Date: 07.31.2019

To: **Ron VanZee, Township Supervisor**
Hayes Township
9195 Old US 31 North
Charlevoix, MI 49720

Project: Camp Seagull

We have completed our analysis of the “areas of concern”, and generated the following report that includes an assessment of each issue, proposed approaches to resolving the issues and an opinion of estimated construction costs for implementation.

FIGURE 4.1

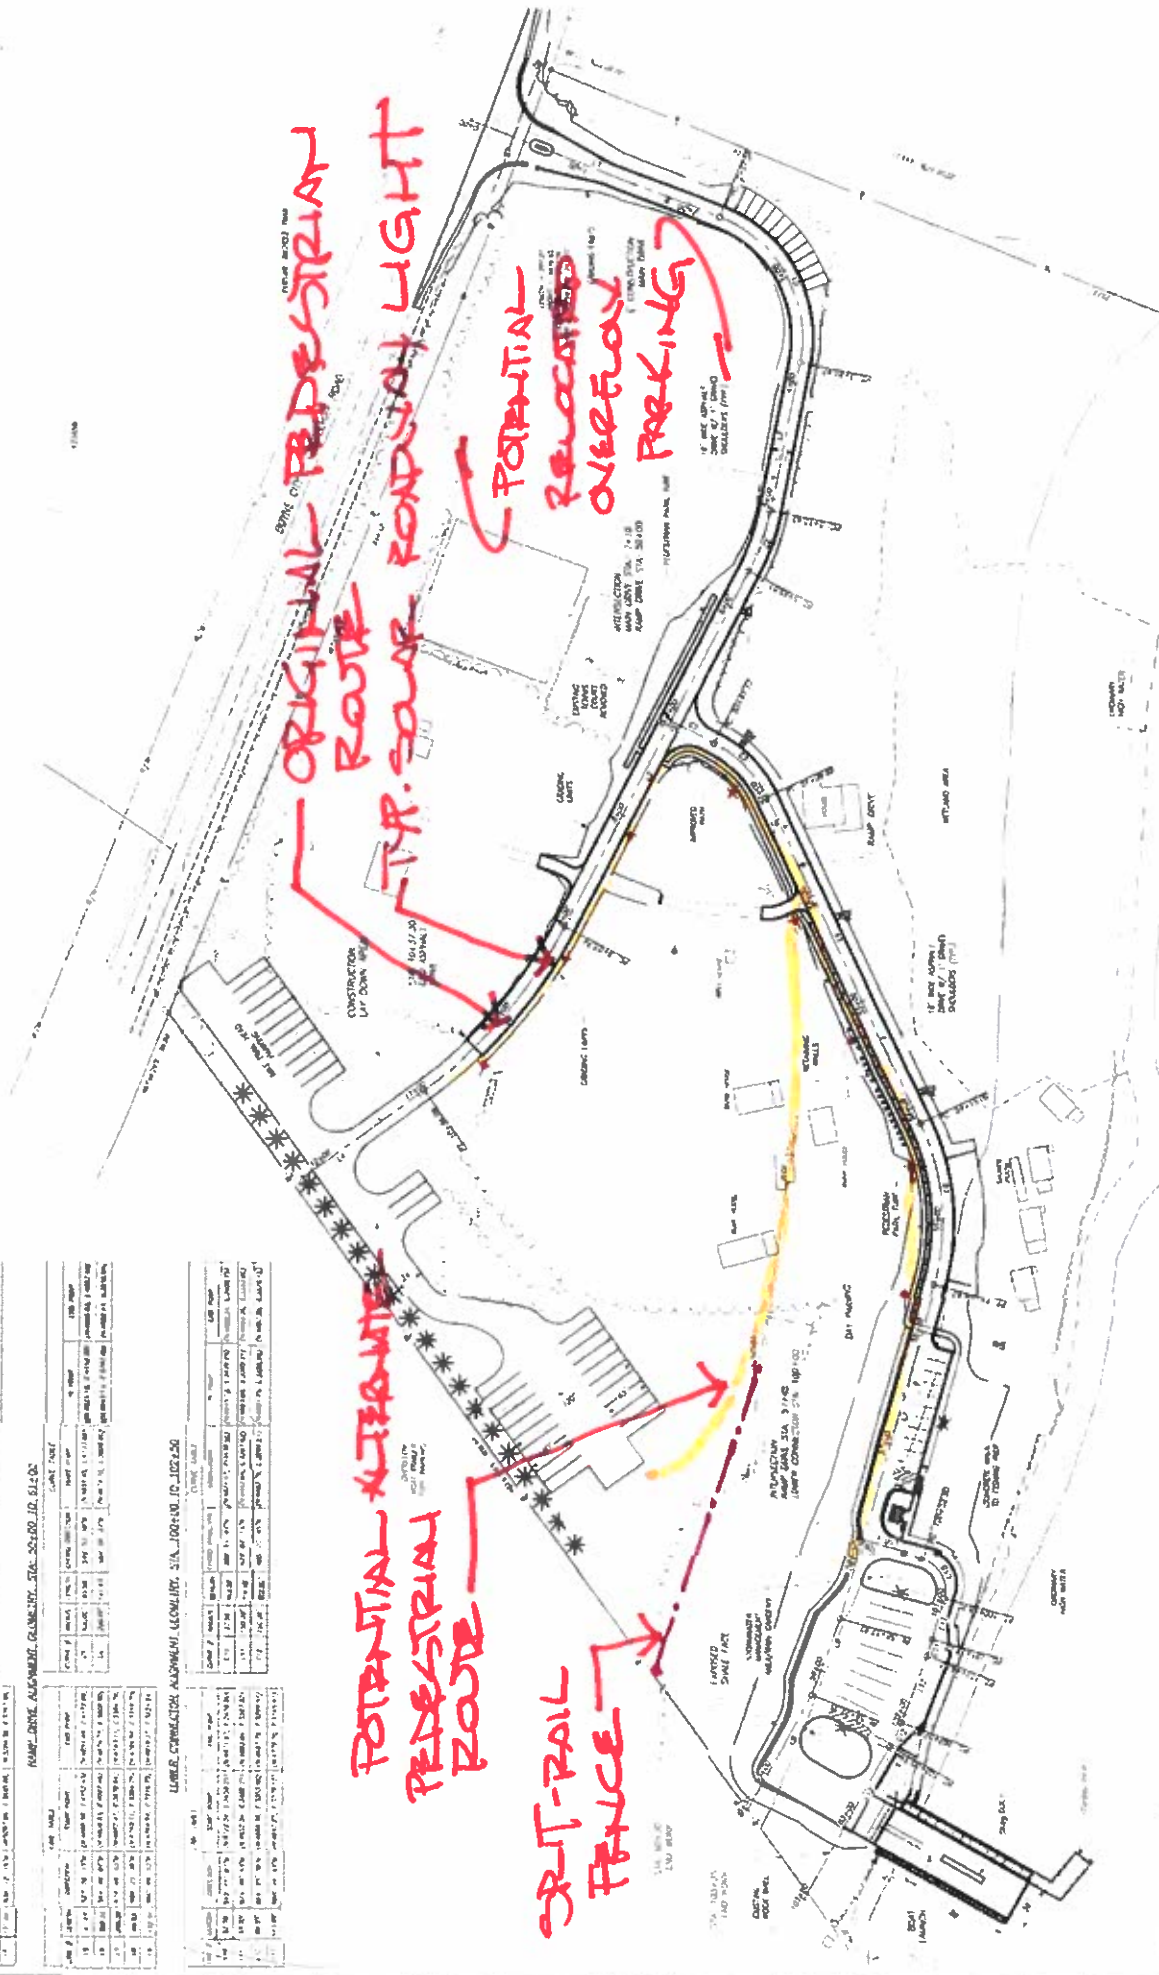
1. Area exists to indicate a pedestrian path route from the overflow parking area to the pedestrian path along the boat launch driveway. This route may be able to run past the amphitheater, and along the south side of the two bunkhouses before connecting with the pedestrian path along the boat launch driveway. See Figure 4.1 for potential route options. Should this route be established, we recommend placement of 450 lf of 42" double split-rail fence, as indicated in Figure 4.1, to notify users of the steep slope beyond. Whether the intended pedestrian route is maintained, or the above modified route is established, the pedestrian route can be indicated by informational "Pedestrian Route" signs at strategic locations.

3. Relocate the overflow parking area from its current location to the open area west of the entry driveway. This option presents a slight advantage regarding proximity to the boat launch drive and pedestrian path. However, potential consequences may include increased pedestrian traffic conflicts along the entry drive.

Street lighting, from boat launch parking to overflow parking,
8 LED overhead lights, 120' o.c. @ \$2,200 ea \$17,600-21,500
(see Figure 4.1 for layout):

FIGURE 5.1a

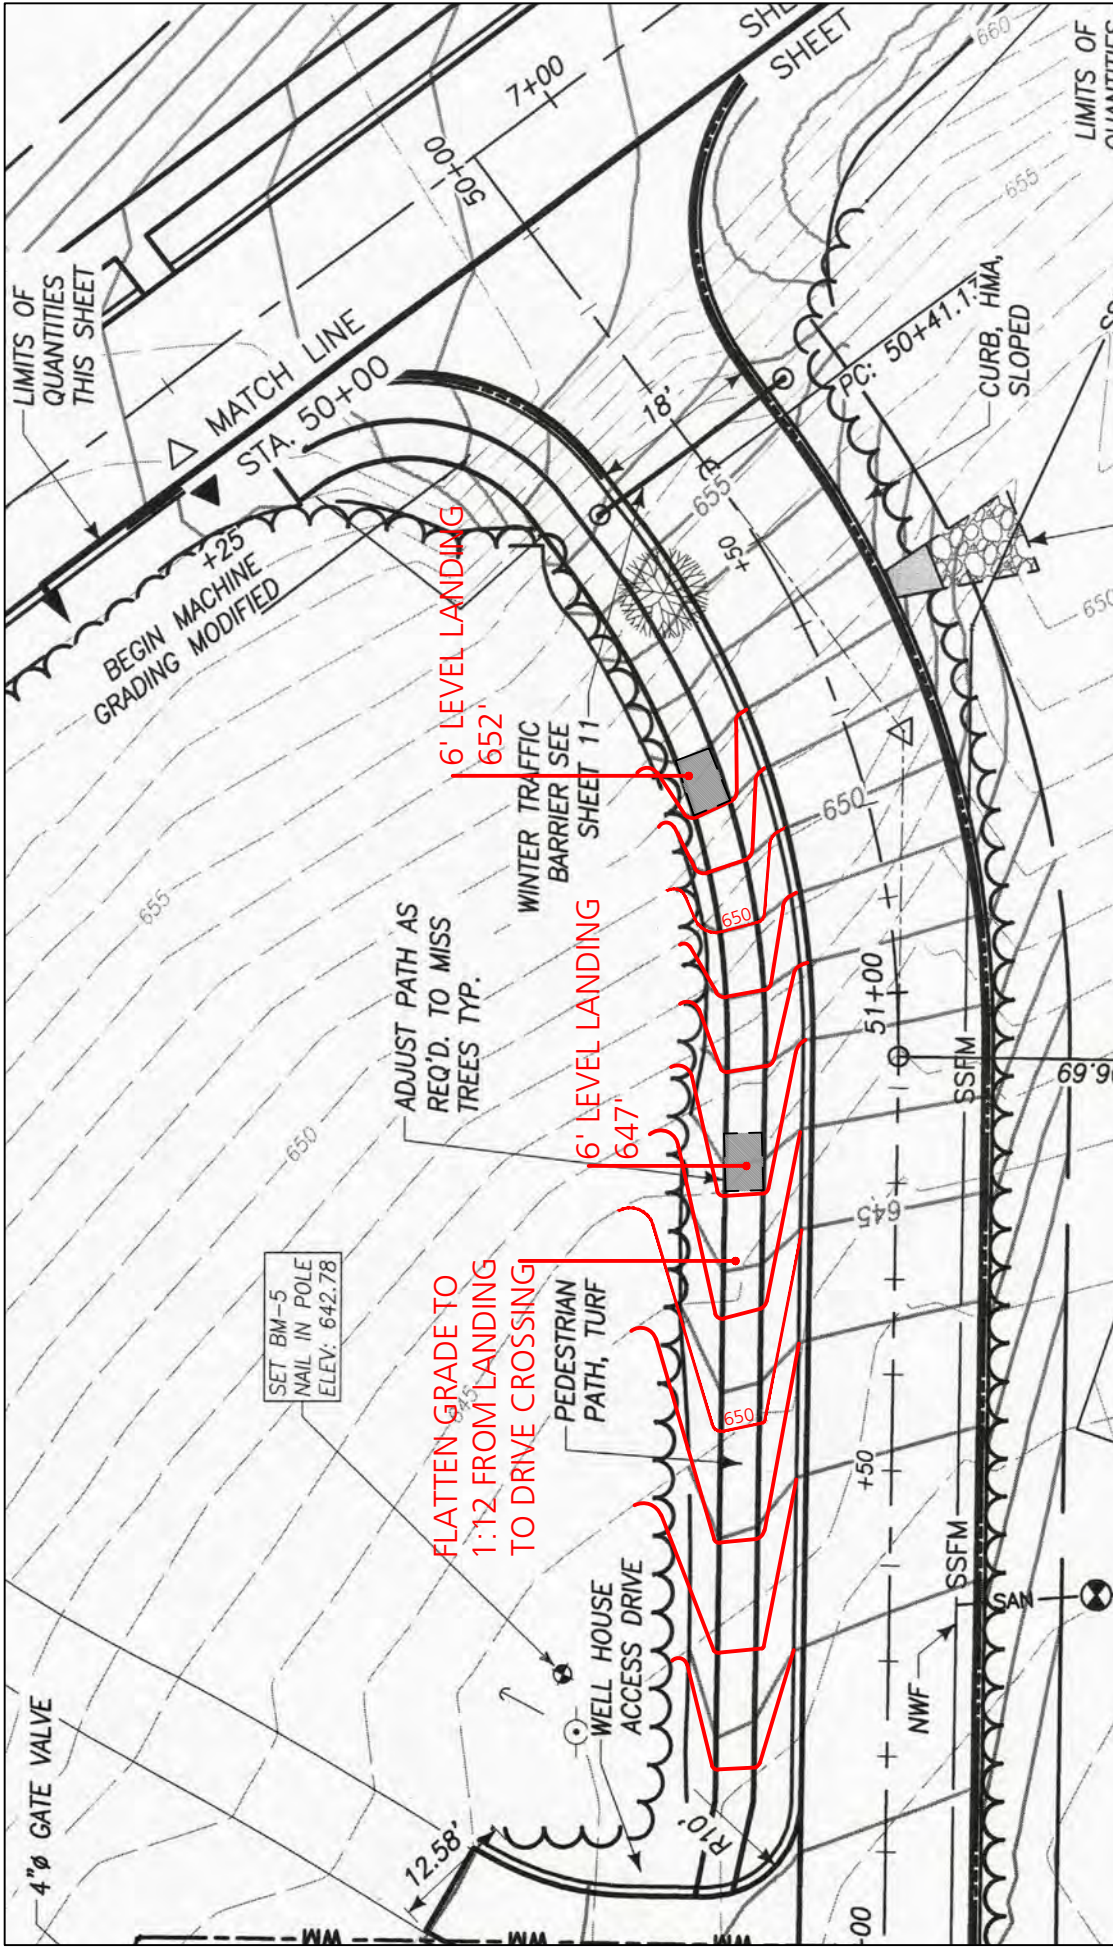
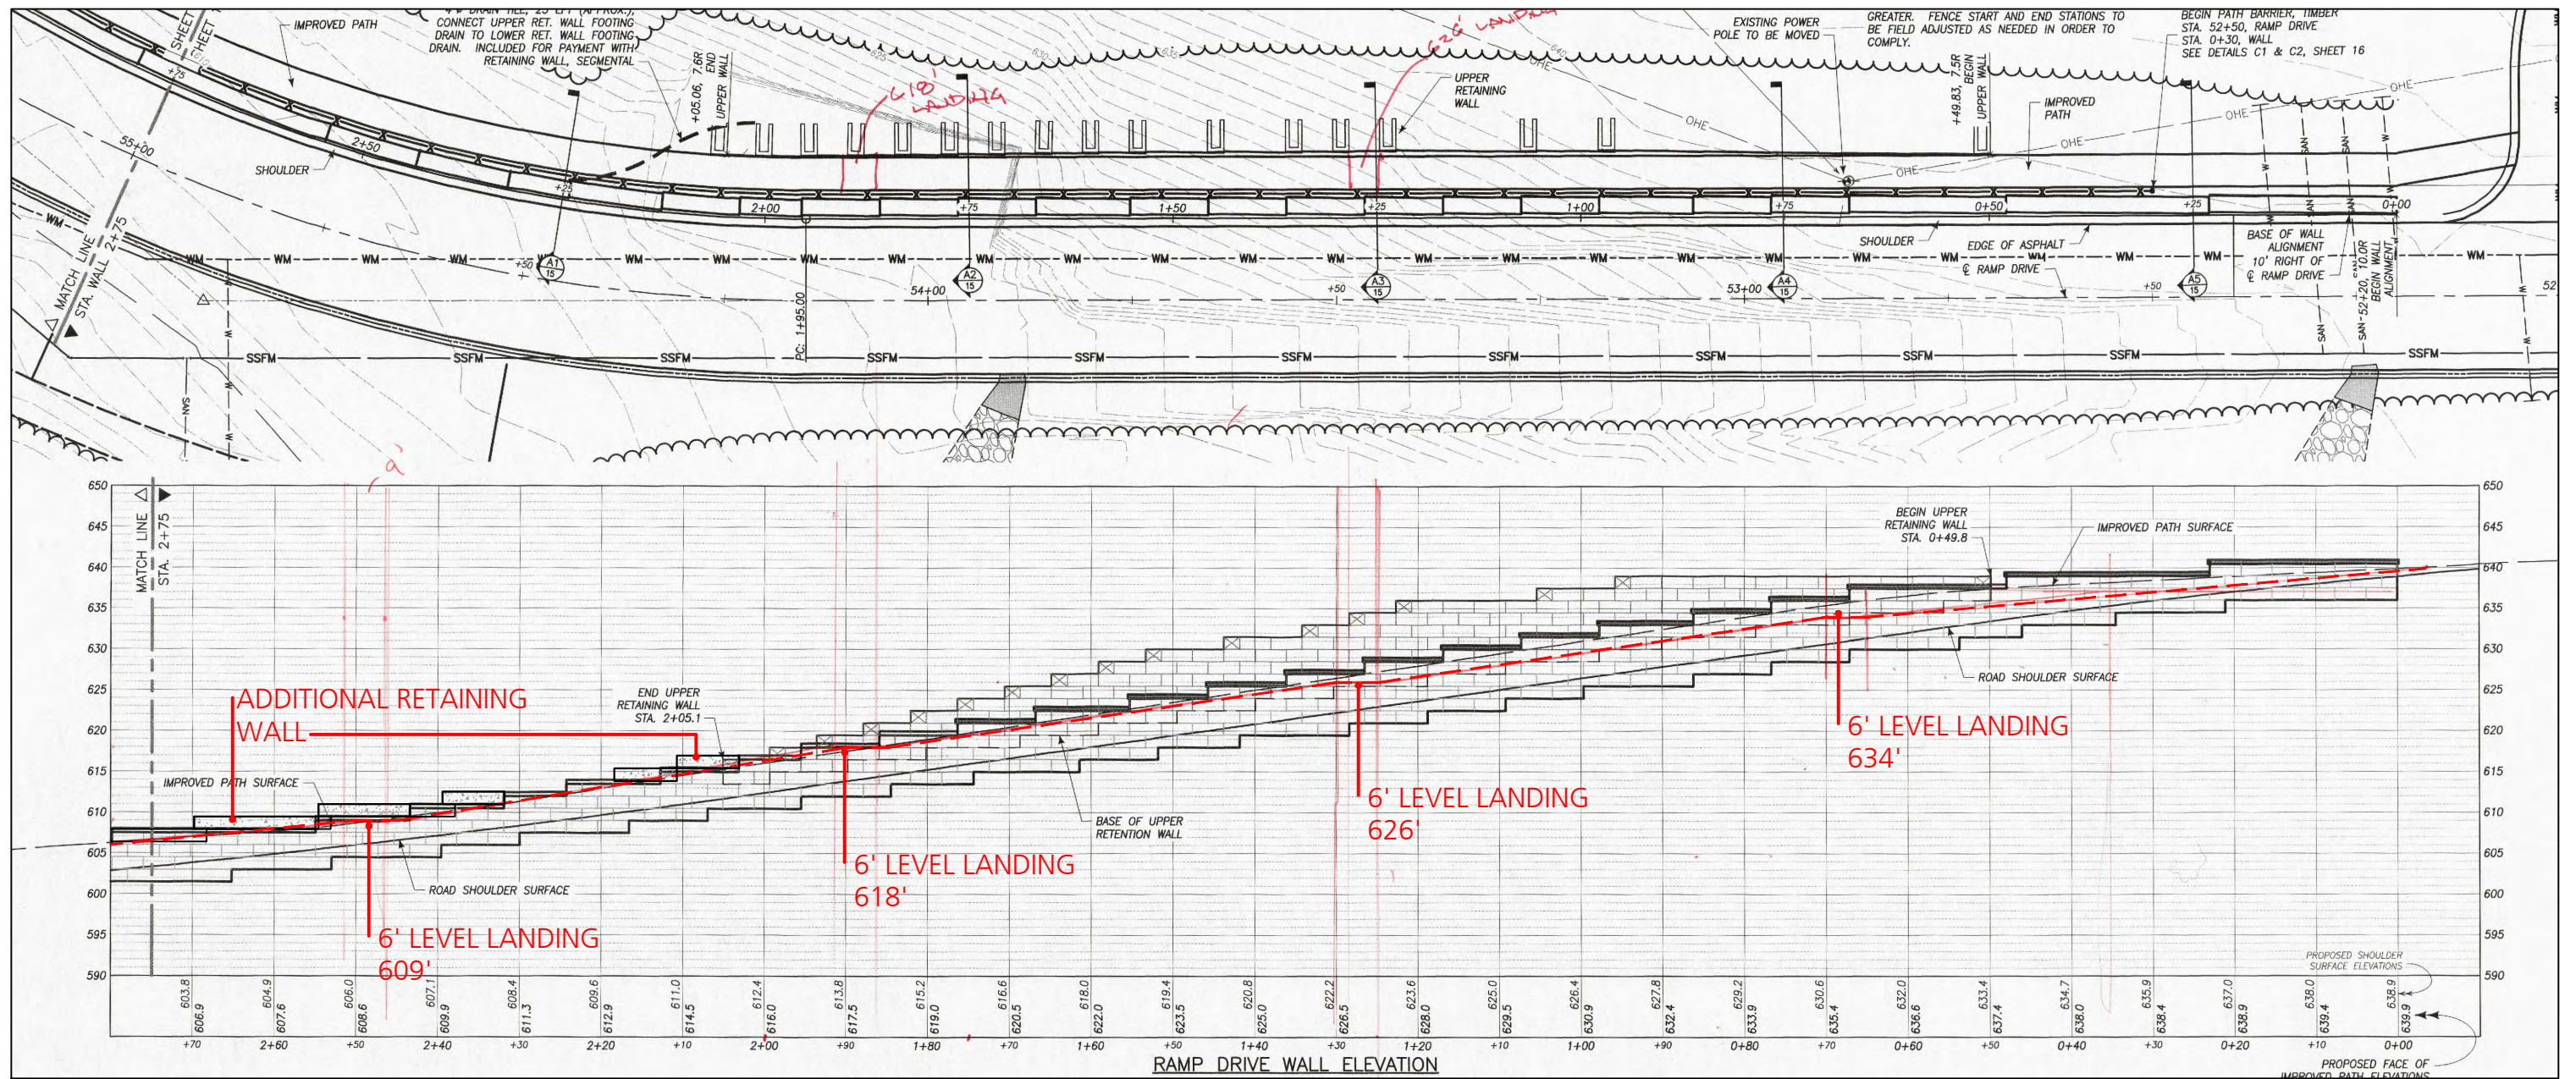
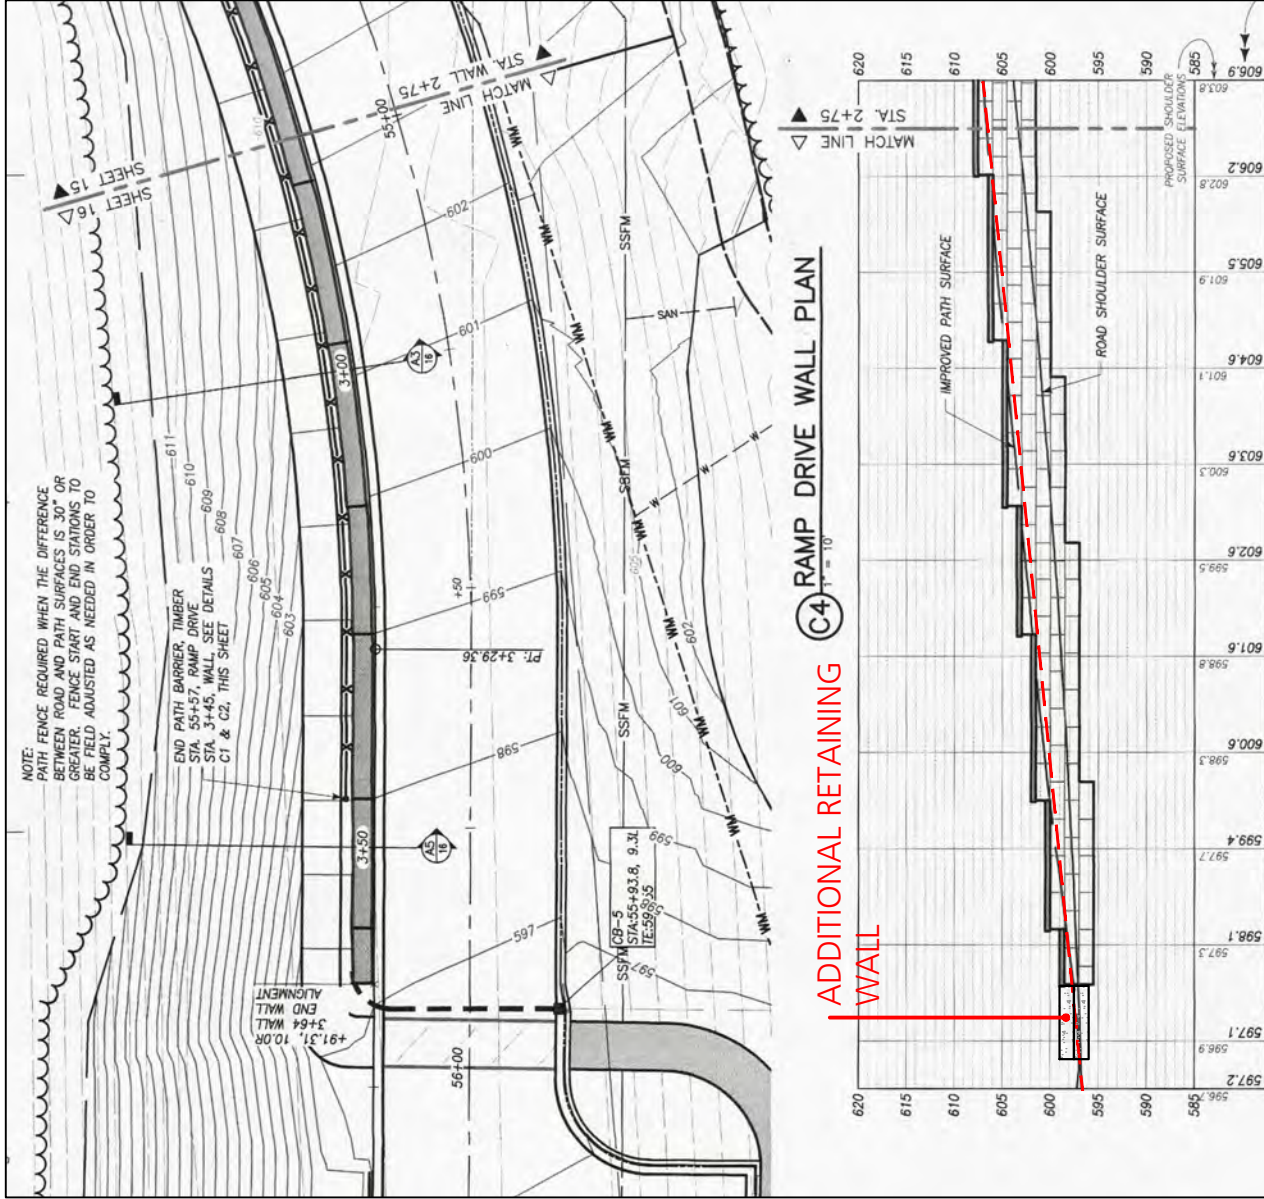
The determination above should not imply that an opportunity does not exist to introduce level landings along the path for pedestrians to rest. This assessment previously mentions a 190' segment of trail that exceeds 14%. Referring to Figure 5.1a-c, we have illustrated that by steepening the more gradual trail segments at the top and bottom of the pedestrian path, it should be possible to introduce level landings at approximately 55' intervals along the steepest section of trail, and at lesser intervals throughout. To facilitate the placement of level landings, approximately 80' of 2' precast concrete unit wall would be required to contain the walking surface, as indicated in Figures 5.1 a-c. Given the steepness of the proposed pedestrian path, the existing condition and the impracticality of meeting the AASHTO shared-use pathway standards or the ADAAG accessibility guidelines, our recommendation would be to include the level landings as indicated in Figures 5.1a-c.
